MCF5407DE/D
Rev. 2.2, 1/2004

MCF5407 Device Errata

This document identifies implementation differences between the MCF5407 processor and the description contained in the *MCF5407 User's Manual*. Refer to <http://www.motorola.com/ColdFire> for the latest updates. The errata items listed in this document (summarized in Table 1) describe differences from the following documents:

Figure 3. Read Data from Read-Modify-Write Operation Erroneously Overwrites Valid Data

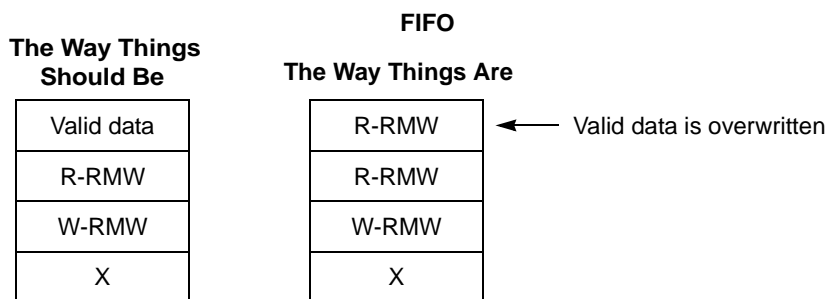
The 5407 debug module includes a 4-entry, first-in, first-out (FIFO) buffer to store read, write, or address captures for output on PSTDDATA[7-0]. Depending upon the amount and sequencing of captures and the latency in processing them for output, the debug module sources a “stall” signal to the operand execution pipeline (OEP). This signal includes terms related to the number of entries in the data FIFO as well as the current pipeline state of data captures in the OEP. A stall is asserted when the data FIFO is filled and remains asserted until it can accept more capture data.

If both read and write data captures are enabled, i.e., CSR[12-11] = 11, the execution of single-cycle read-modify-write instructions result in two data operands being captured: first the read data and then the write data. In the current design, the generation of the pipeline stall signal does not correctly account for this condition. Depending on the amount and sequencing of previous captures, one FIFO location can be overwritten. Therefore, one incorrect data word is output from the core. The valid data that should have been output will be overwritten in the FIFO by the RMW instruction. This data will be followed by the RMW data. The read-modify-write instruction captures will be output correctly as will all subsequent instructions and data captures.

This “one incorrect PSTDDATA output” scenario can occur anytime a read-modify-write instruction occurs with only one entry in the PSTDDATA FIFO being available.

Do not enable both read and write captures; that is, don't set CSR[12-11] = 11. Enabling read or write data captures separate functions correctly.

Another possible workaround would be to guarantee no single-cycle RMW instructions reference addresses mapped into cache or on-chip memories.

Figure 4. Undershoot Voltage

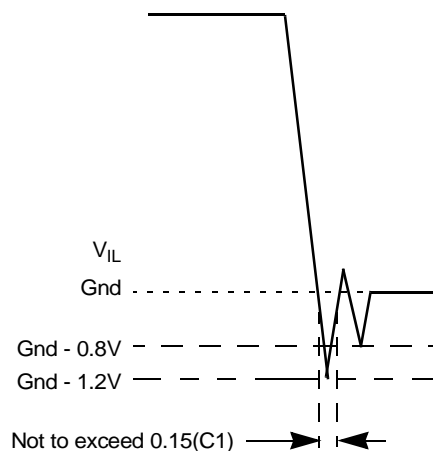
Characterization of the 5407 device has indicated that certain specifications must be modified as shown in Table 4.

Figure 4 shows the allowable undershoot voltage on the MCF5407. Note that a 1.2V undershoot is only allowable if it is present 1% or less of the total processor operating time.
